CITY OF CODY
PLANNING, ZONING AND ADJUSTMENT BOARD
TUESDAY, SEPTEMBER 12, 2017
CITY HALL COUNCIL CHAMBERS @ 12:00 NOON

MEETING DATE:	SEPTEMBER 12, 2017	TYPE OF ACTION NEEDED	
AGENDA ITEM:		P&Z BOARD APPROVAL:	X
SUBJECT:	CONDITIONAL USE REQUEST BY T-MOBILE FOR A WIRELESS COMMUNICATIONS FACILITY AT THE RILEY ARENA. CUP 2017-10	RECOMMENDATION TO COUNCIL:	
PREPARED BY:	TODD STOWELL, CITY PLANNER	DISCUSSION ONLY:

MEETING DATE:	MAY 23, 2017	TYPE OF ACTION NEEDED	
AGENDA ITEM:		P&Z BOARD APPROVAL:	X
SUBJECT:	SITE PLAN REVIEW: VALOR HEALTHCARE MEDICAL SERVICE CENTER (VA CLINIC). SPR 2017-20	RECOMMENDATION TO COUNCIL:	
PREPARED BY:	TODD STOWELL, CITY PLANNER	DISCUSSION ONLY:

EQUIPMENT LAYOUT

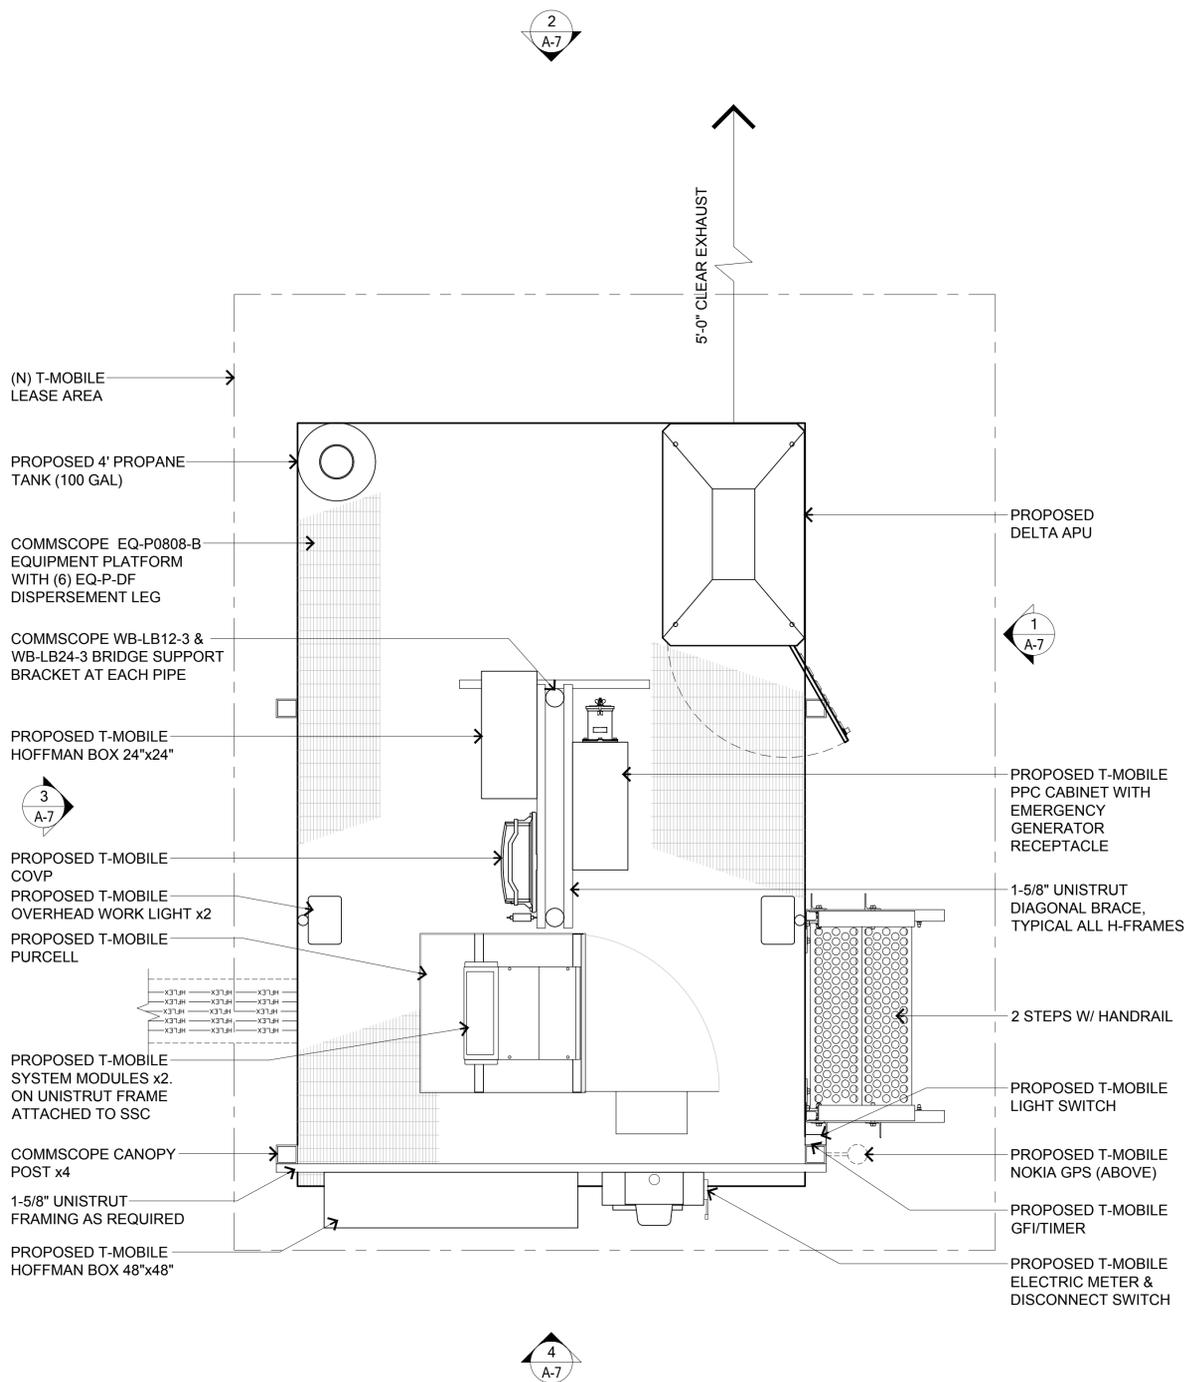
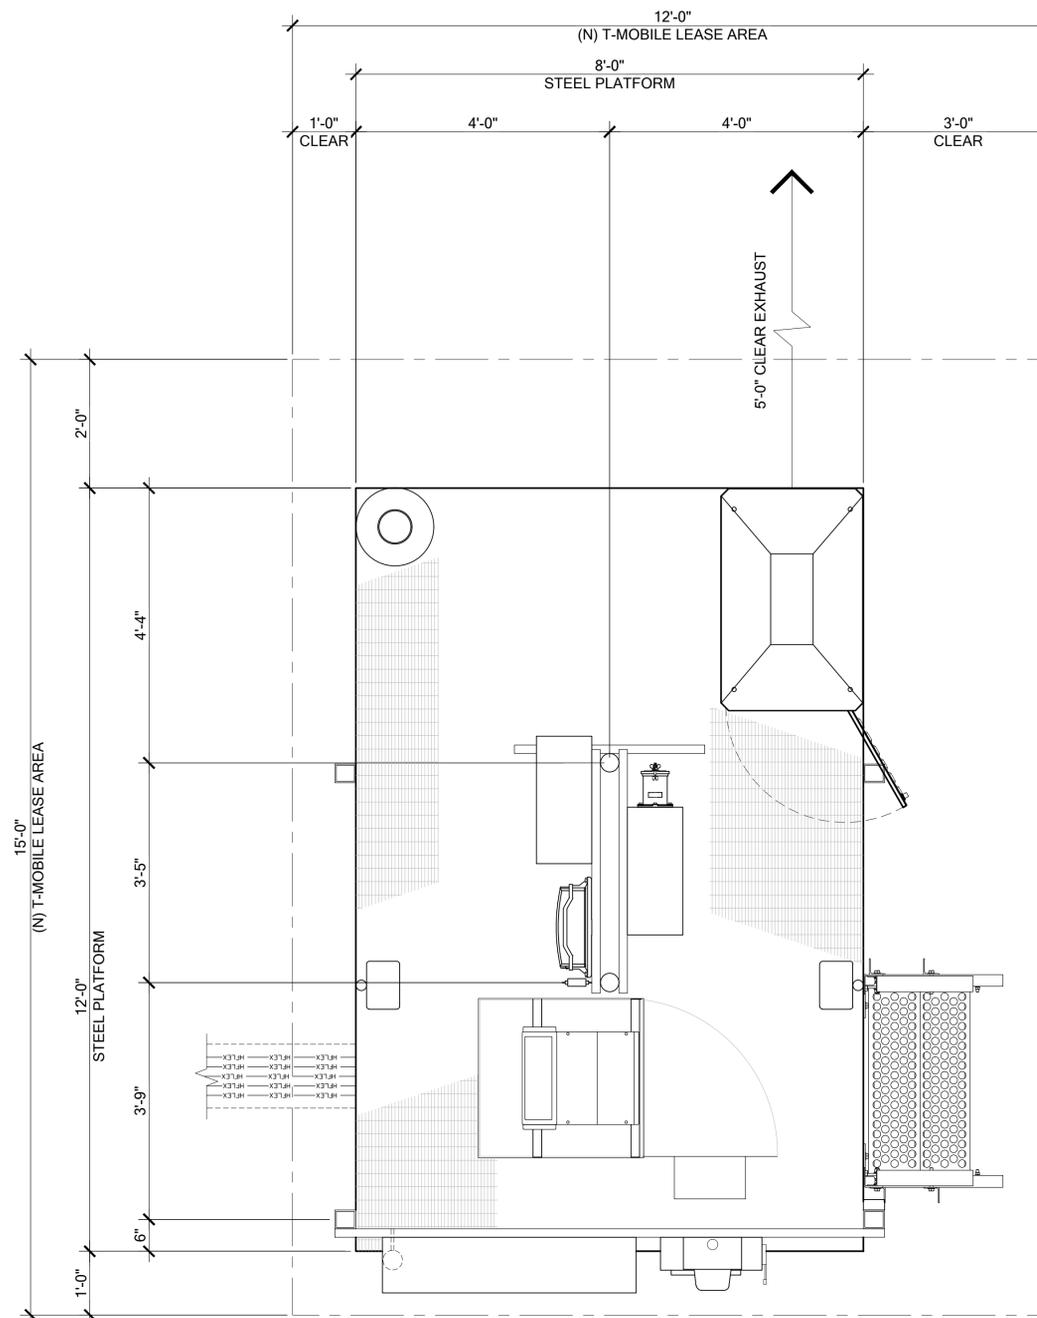
Comment: The ground equipment drawings show an emergency generator receptacle and 100-gallon propane tank, but no generator. If a generator is proposed, the applicant should provide details. In addition, depending on the sound levels, the generator should be required to have a sound reduction package and regular testing/maintenance of the generator should be limited to 8 a.m. to 6 p.m.

EQUIPMENT ELEVATION - WEST

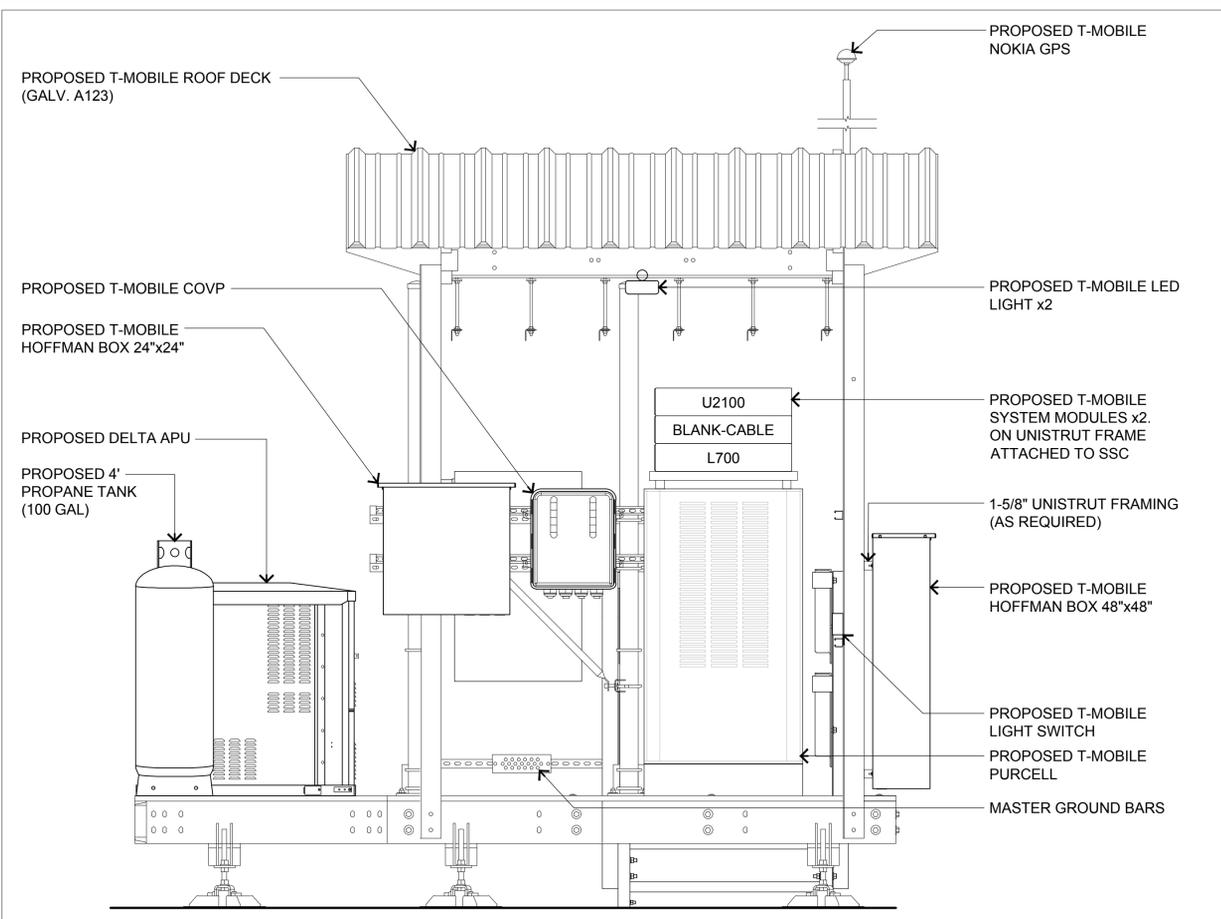
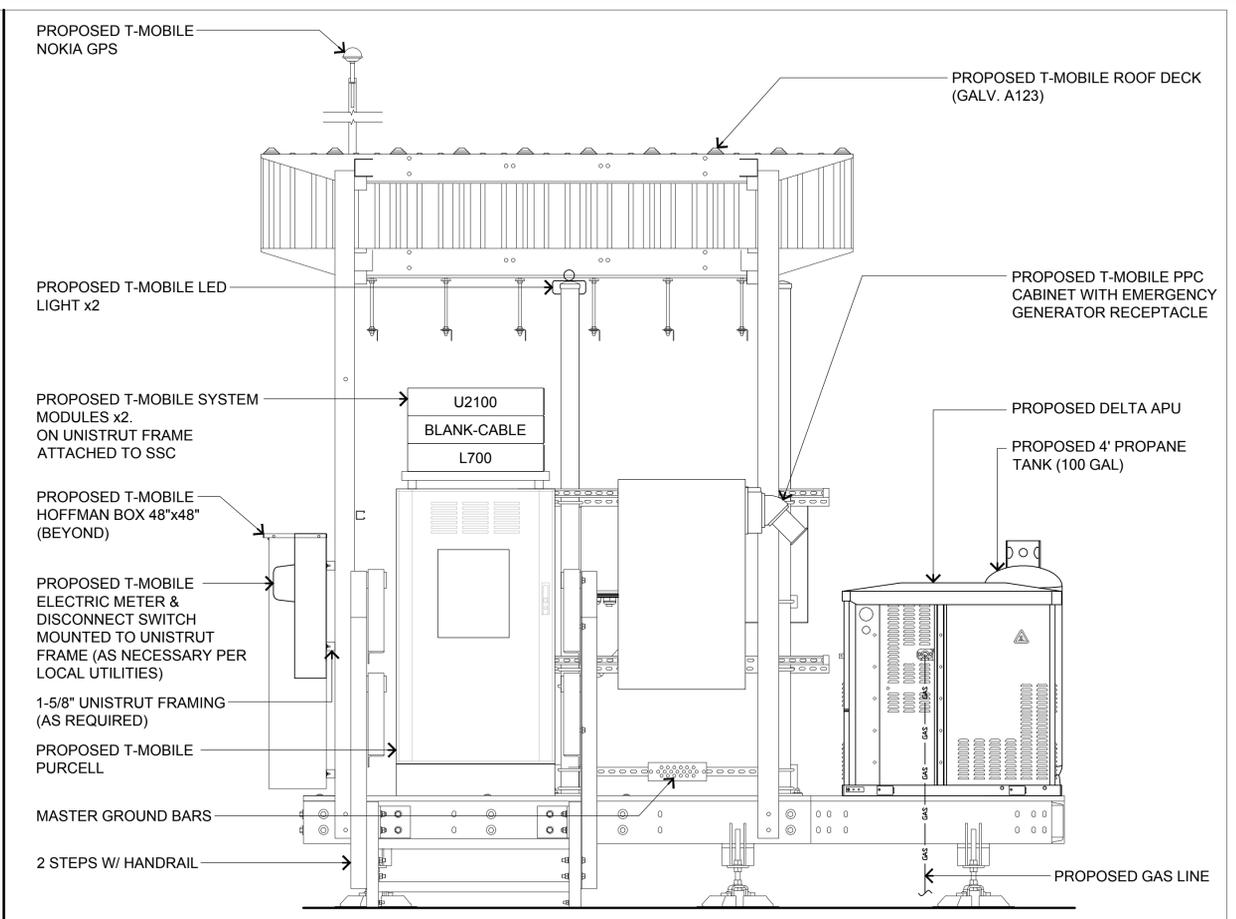
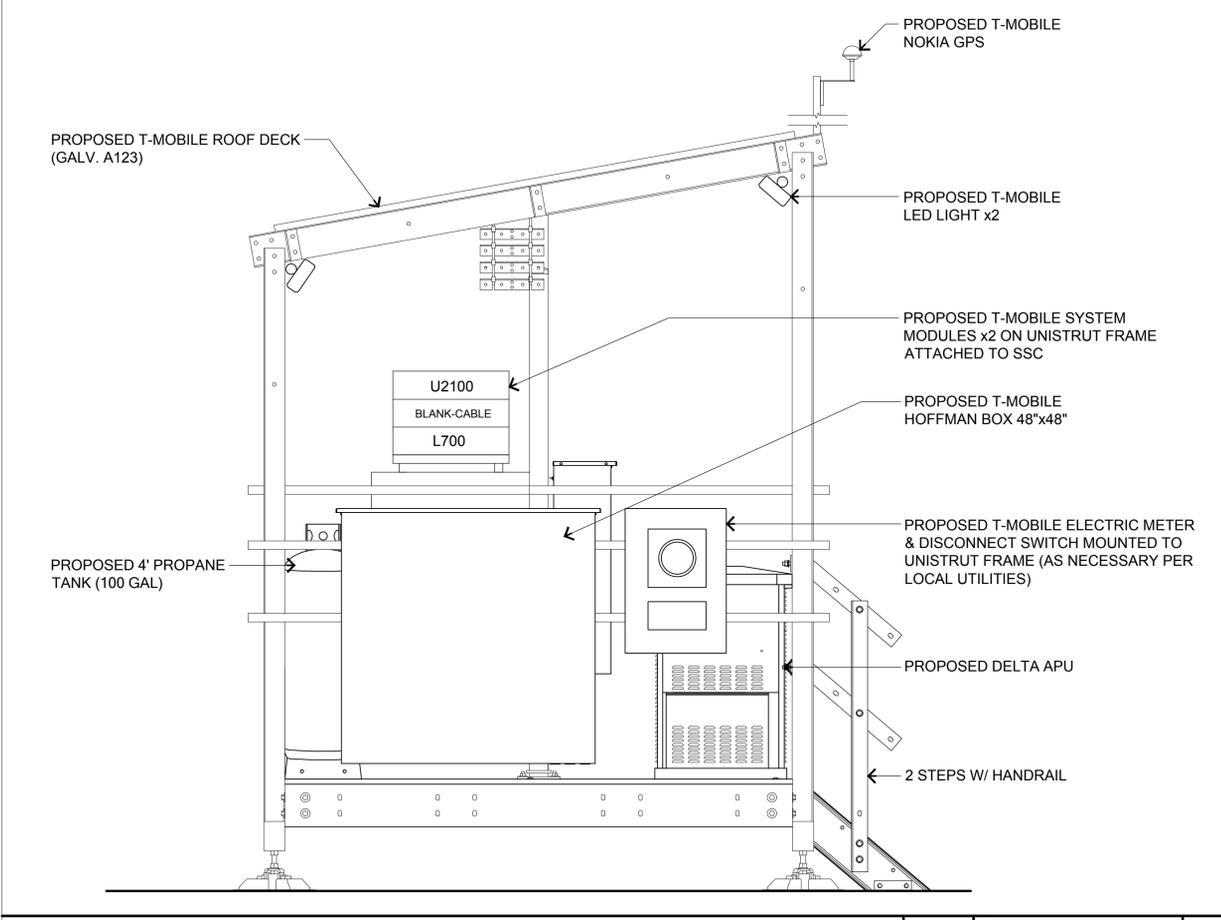
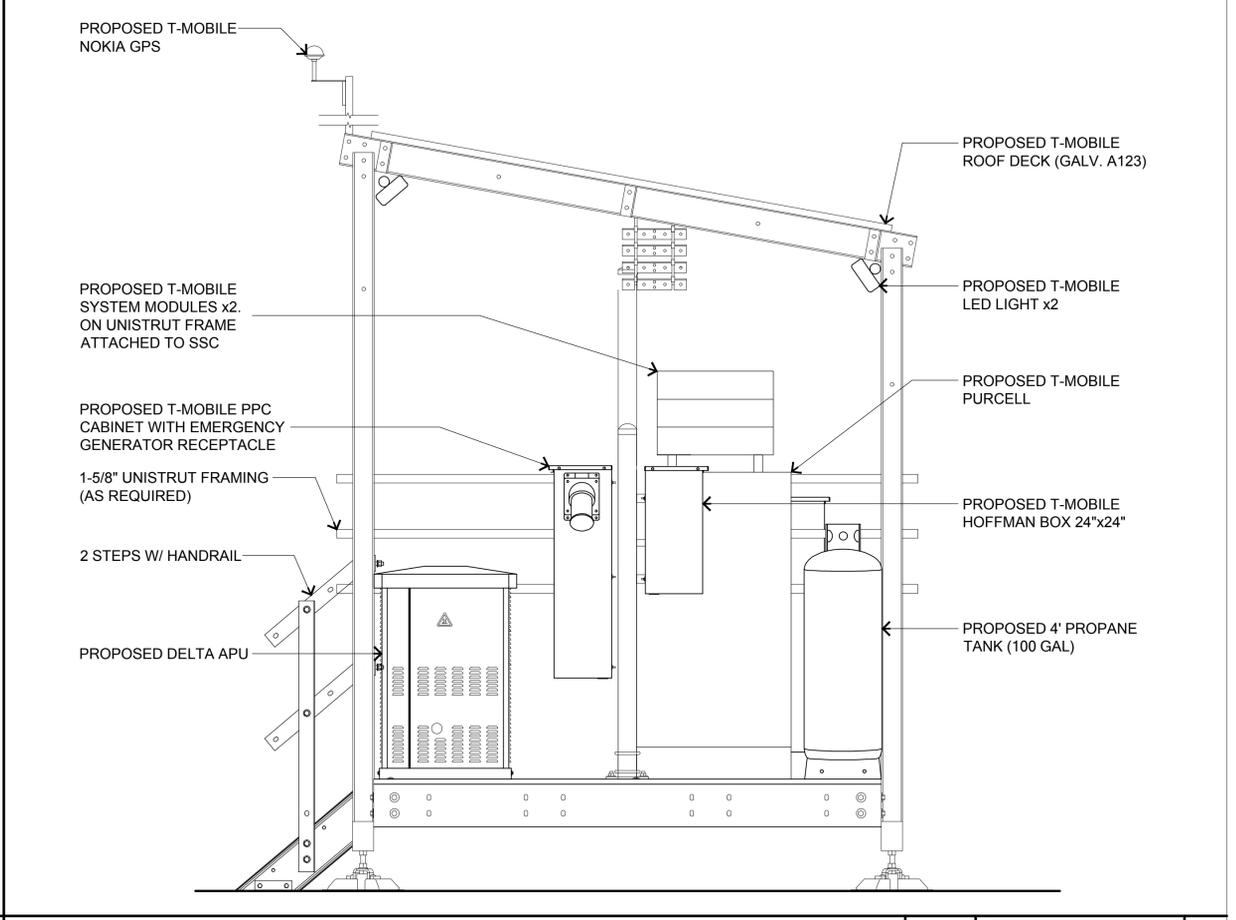
Comment: The proposal is to fence the ground equipment platform with a slatted chain link fence. Based on neighbor comments about the overall appearance of the west end of the Riley Arena property, staff is recommending an alternative to better screen the ground equipment area. Staff recommends an 8-foot tall masonry wall on the west end of the equipment platform of the same block as the Riley Arena building. This method is used for the adjacent aquatic center to screen pumps and HVAC equipment and would appear as a natural part of the original building. Below is a photo of the method and colors recommended. The extent of the wall does not need to be the same as the fence would have been, but could simply extend from the wall at the northwest corner of the ground lease area to a point that the line of sight between the masonry wall and the northwest corner of the recreation center building blocks the ground equipment (approx. 10'). Whether the screen wall is the responsibility of T-Mobile or the Riley Arena, we will let them negotiate.

3. The vertical run of wire near the ground equipment must be enclosed within a solid chase (e.g. sheet metal).
4. Provide an 8-foot tall masonry wall to screen the ground equipment area from public view (see line of sight drawing). The wall must be of the same color and material as the screened area at the aquatic center (see photo).

FRONT ELEVATION
 1/4"=1'-0"

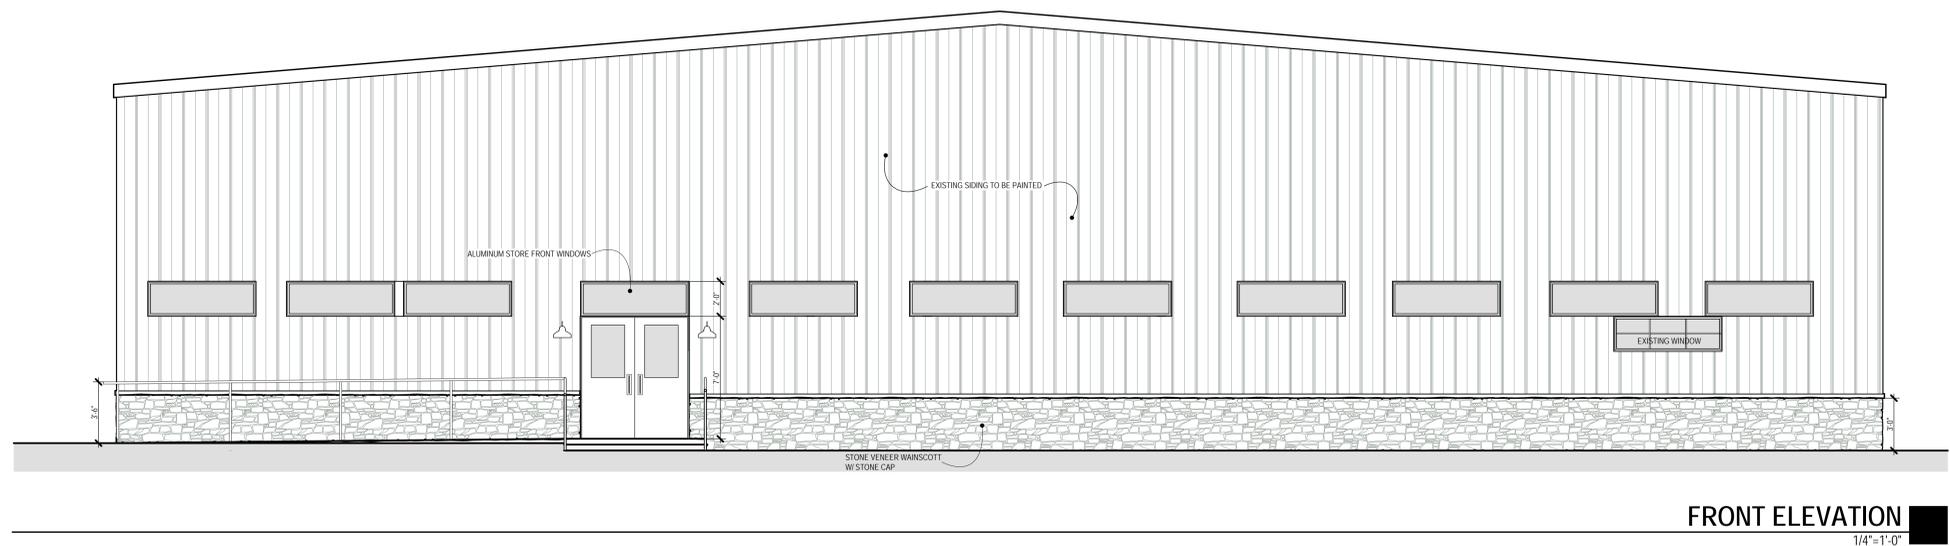
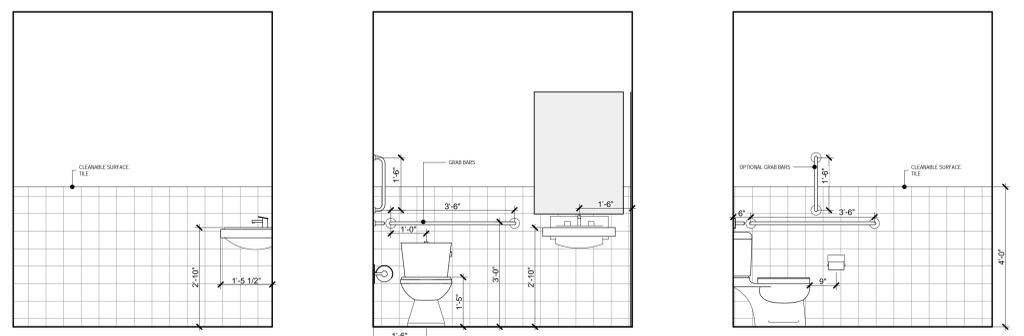
Refer to the architectural sheets (A1.0 Demolition Plan, A2.0 Main Floor Plan, and A4.0 Front Elevation) for the description of the architectural changes to the building. In summary, unused doors and windows will be removed and infilled; eleven new windows, a new entry door, and a 3-foot tall wainscot will be installed on the 19-foot tall front of the building; emergency doors will be added to the east side of the building; and, all exterior walls will be painted. Details of a color scheme for the wainscot and paint have not been supplied.

3. Remove the conflicting on-street parking space striping—coordinate method with Public Works.
4. The painting of the exterior must utilize at least two complimentary tones on each wall, and the colors must coordinate with the masonry wainscot. (e.g. Walmart example).

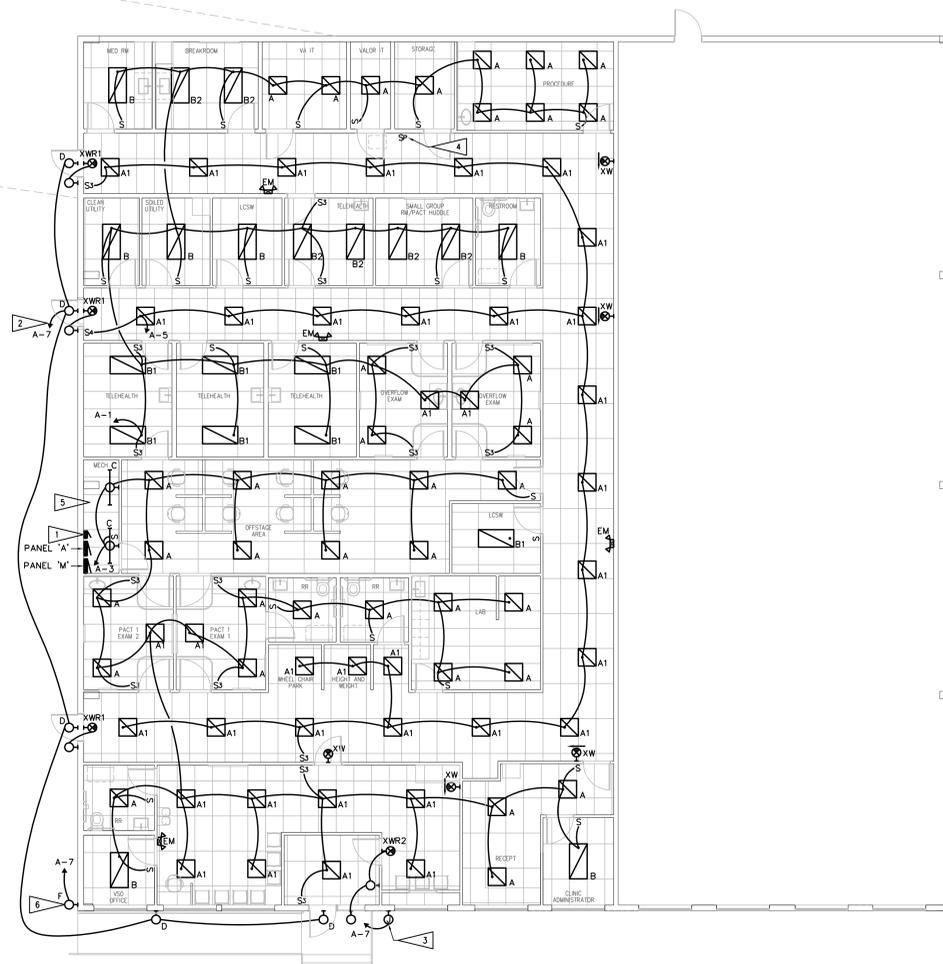
The lighting details are provided on Sheet E1.0. Exterior lights are provided at each of the doors and a flagpole light is proposed on the NE corner of the building. The parking ordinance requires the lighting of any parking lot used at night. As sunset is as early as 4:36 p.m. in the winter in Cody, the clinic will have personnel and customers when it is dark.

The combination of building lighting and the City street light at the NW corner of the property conceptually should work to provide adequate parking lot lighting. However, it does not appear that any analysis of the parking lot lighting levels has been done in the exterior lighting design. The spacing is based on providing light at each exterior door, rather than in the context of parking lot lighting. As a result, lighting levels would be widely varied. Staff recommends that the applicant analyze the exterior lighting levels in the context of providing parking lot lighting and submit a new plan for Planning and Zoning Board approval. The resubmittal of the exterior lighting plan need not delay authorization of the rest of the project.

2. Provide a revised exterior lighting plan for review and approval by the Board. The plan must provide adequate parking lot lighting and avoid any glare impacts.
